DEVELOPMENT REVIEW COMMITTEE (DRC) COMMENT REPORT

Project Name: 353 Sunset, LLC / 353 Sunset Drive Residences

Case Number: R15008

Request: Site Plan Level III Review: Eight (8) Multi-Family Units

A-6

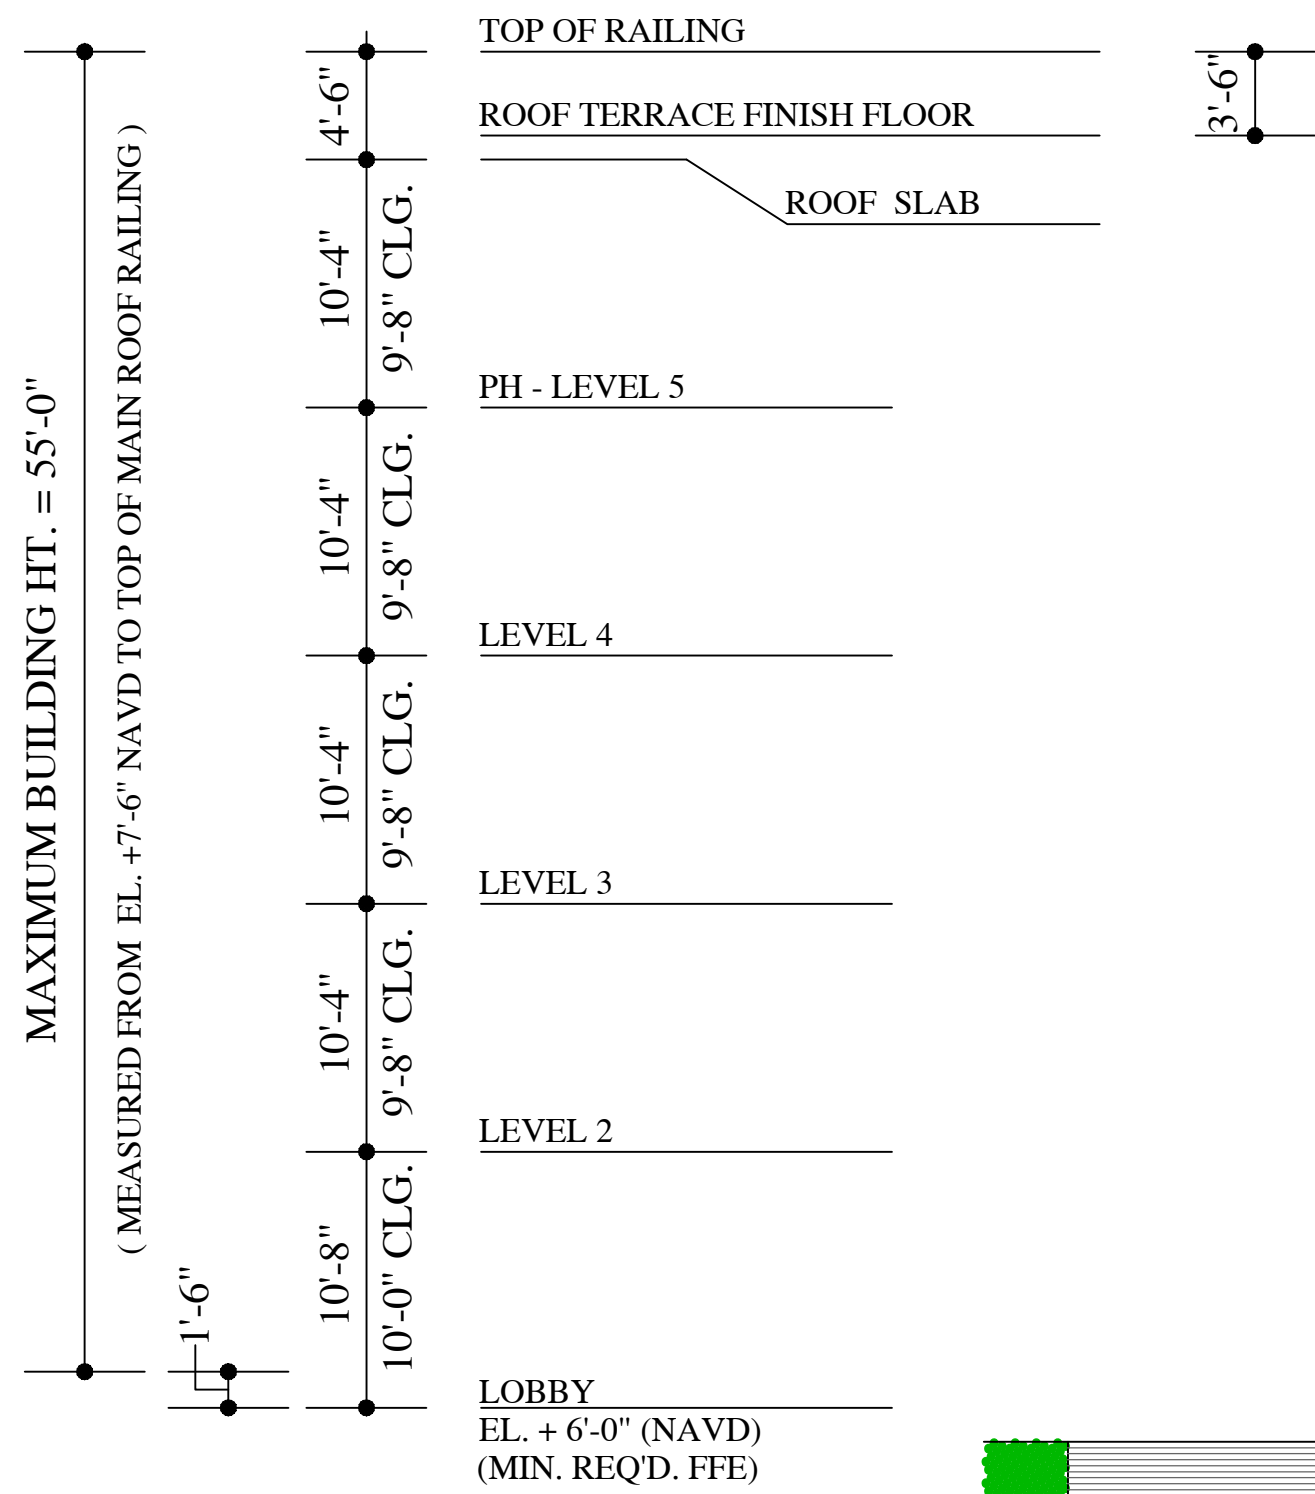
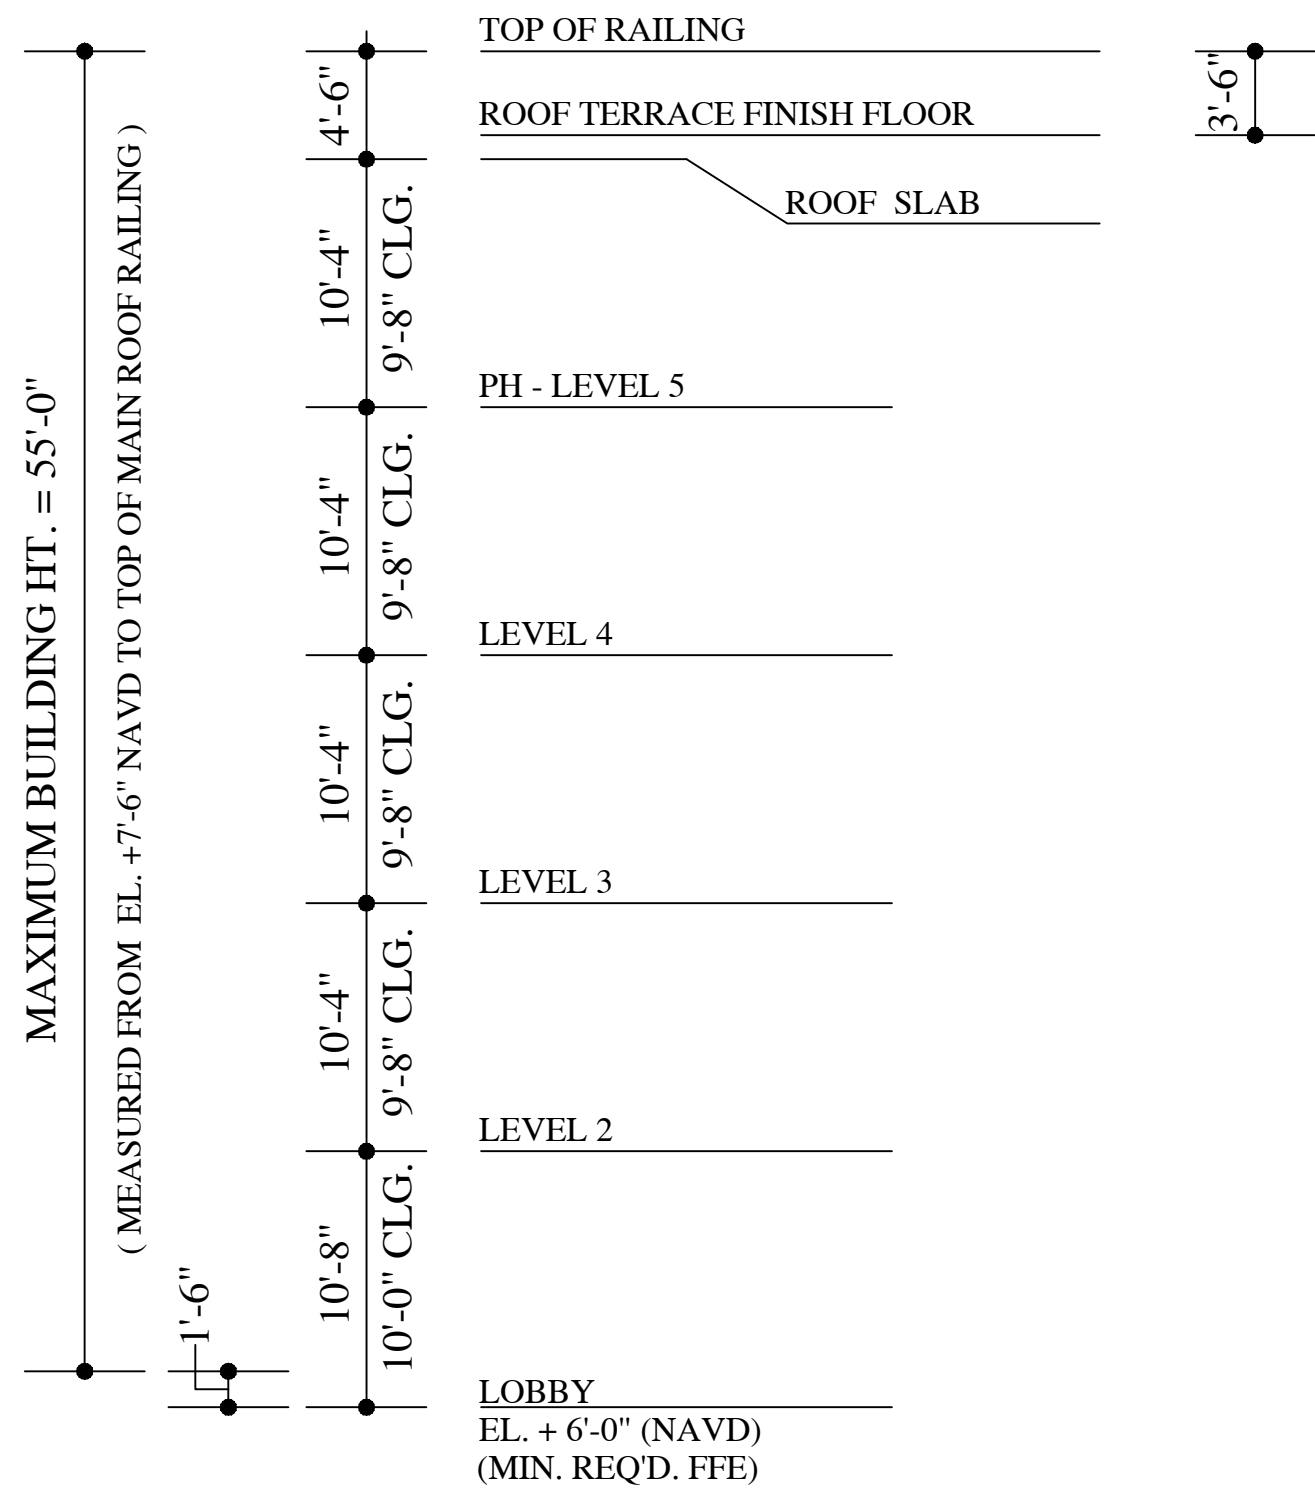
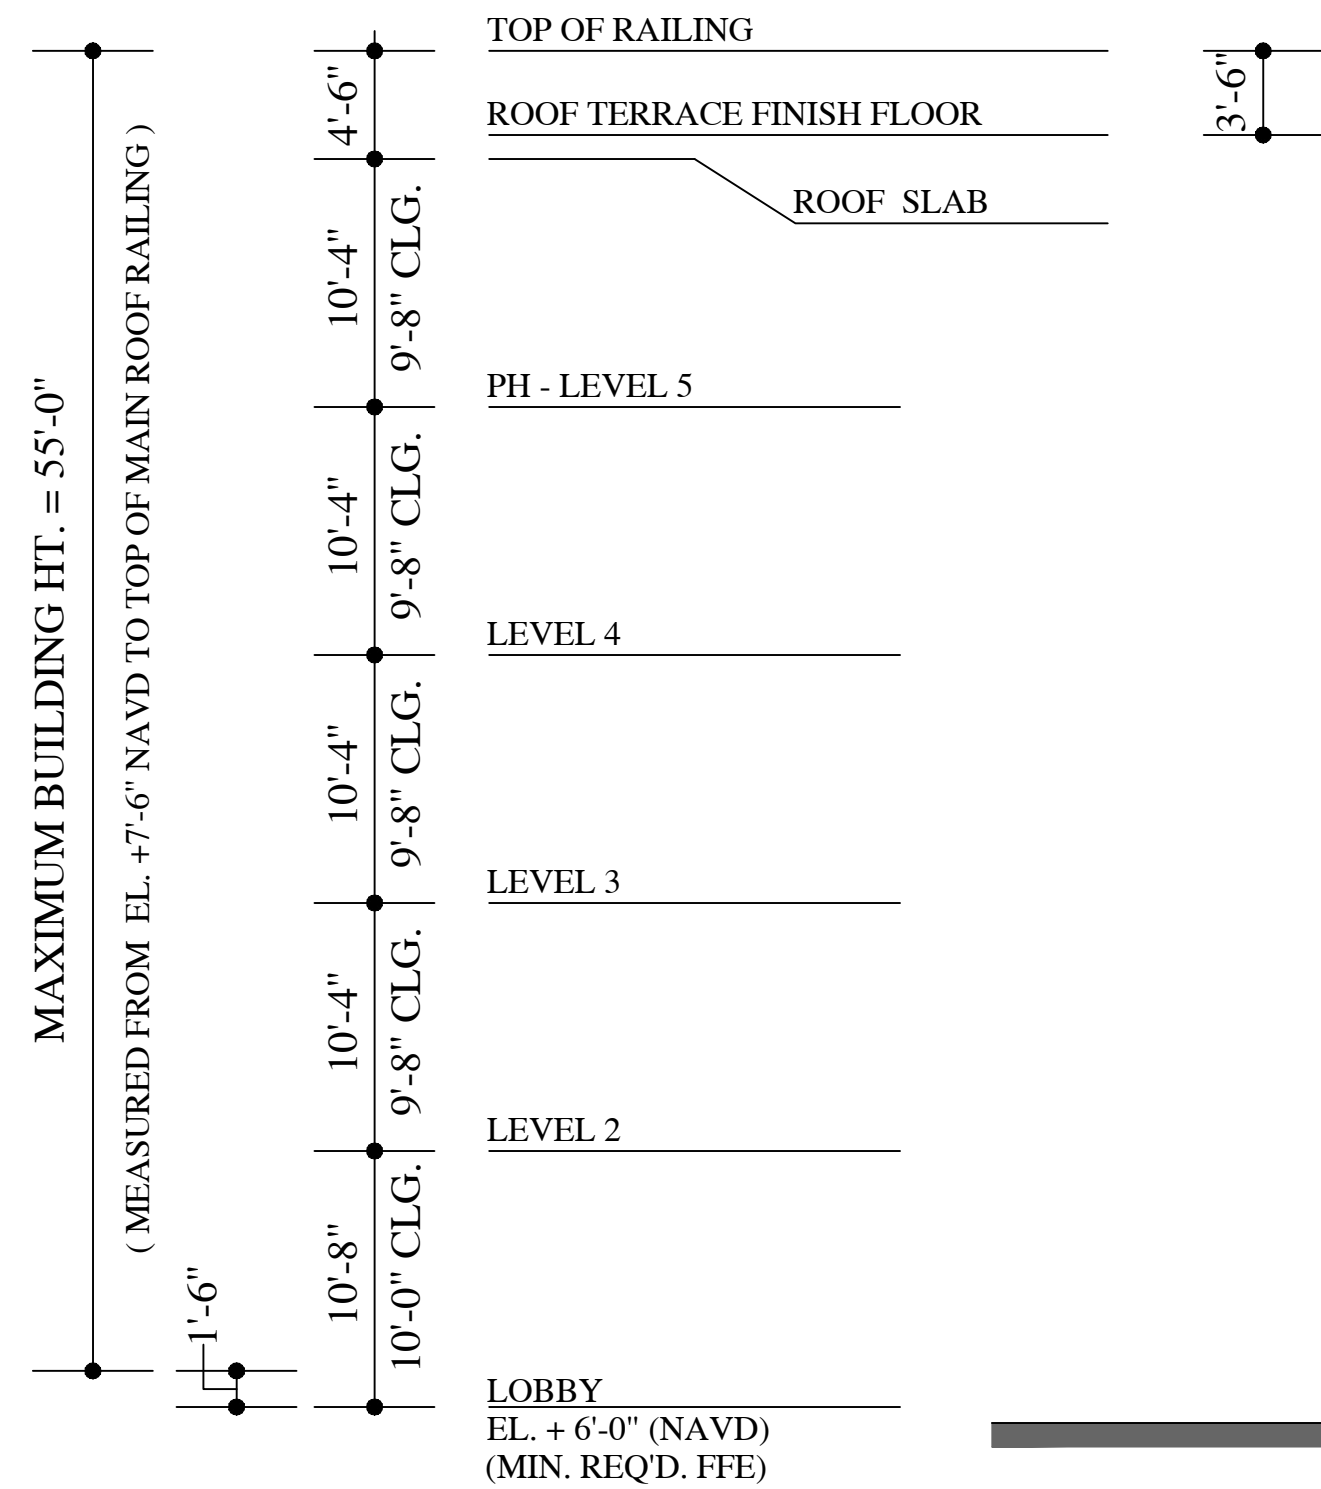
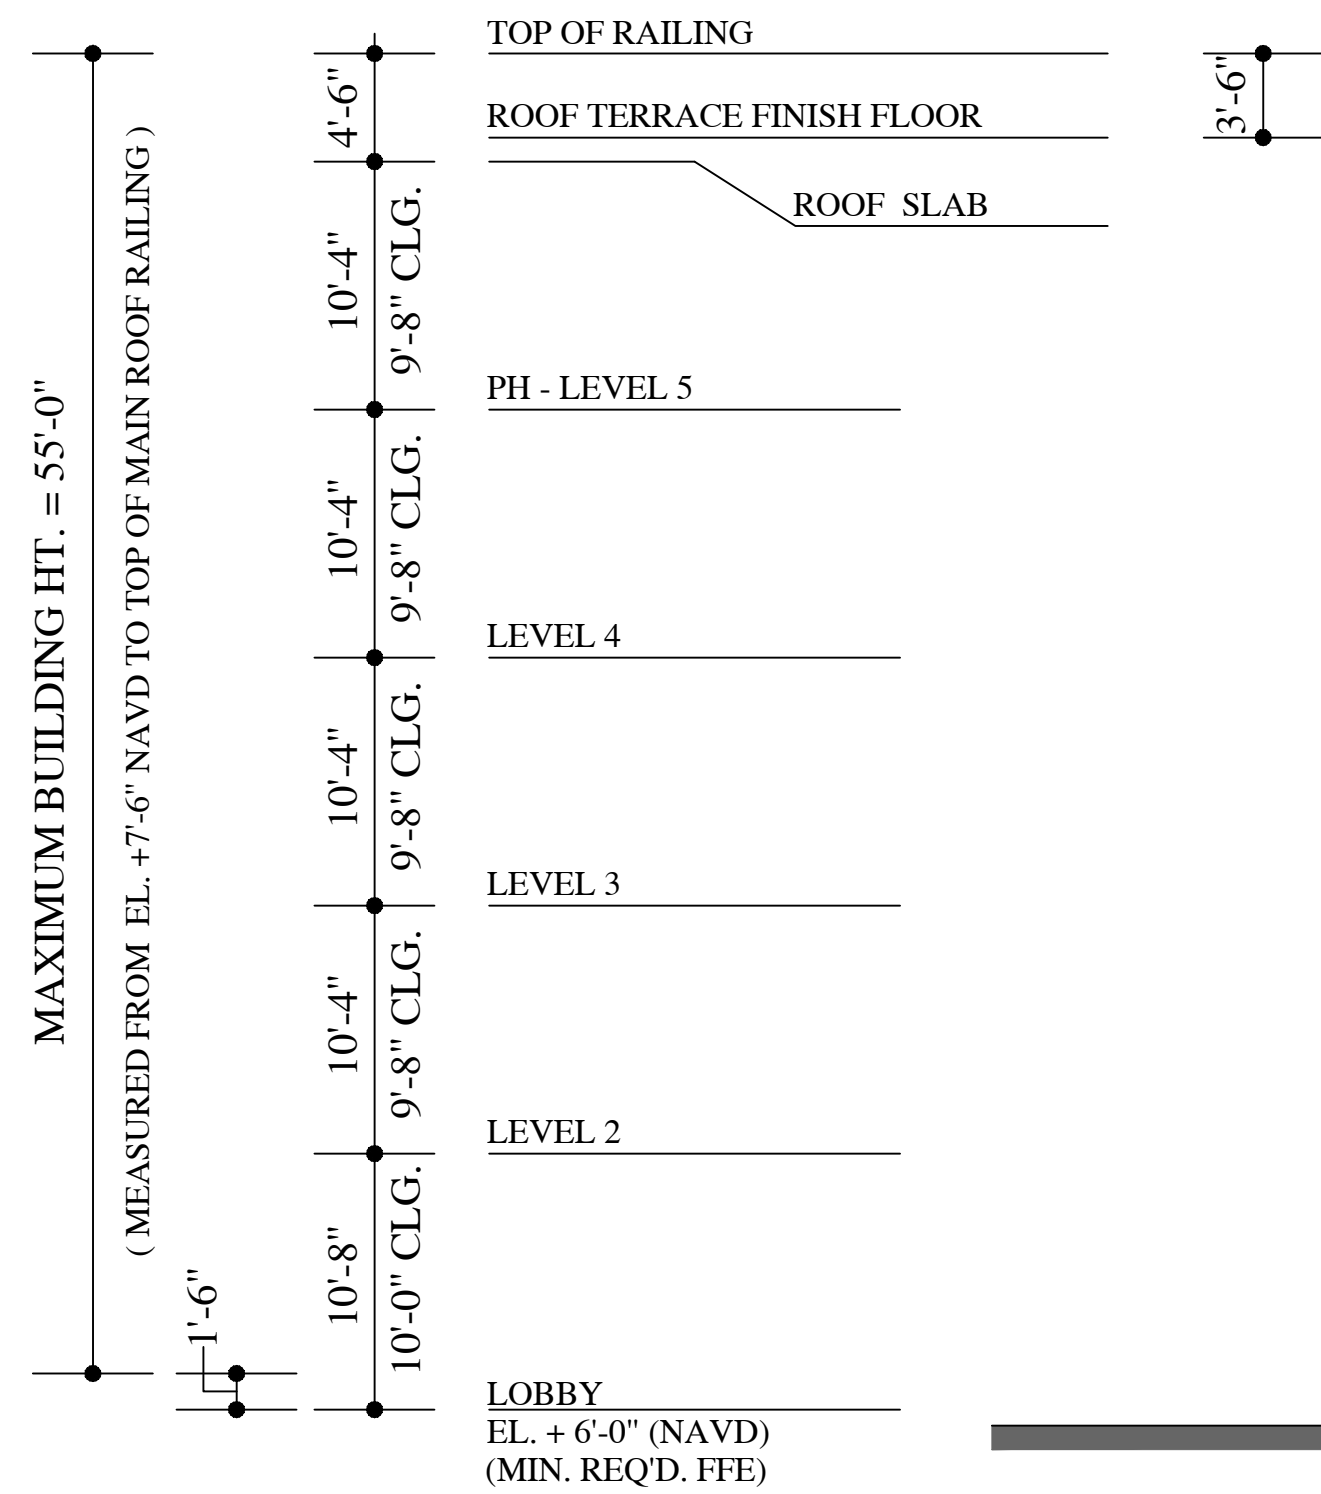
- 5) Attach ULDR response narratives to criteria to Planning & Zoning Board sets and Final DRC sets.
- 6) In order to create a more active building façade from the waterway and better screen the parking garage, consider individual staircases from each second floor unit down to the ground at each side, and opening the view to the water from the lobby entry by shifting two center parking spaces inward. This will not only enhance the look of the building from the waterway, but allow direct access for residents and views from the lobby to the waterway.
- 7) Confirm use of clerestory windows on garage to further enageg the blank facades.
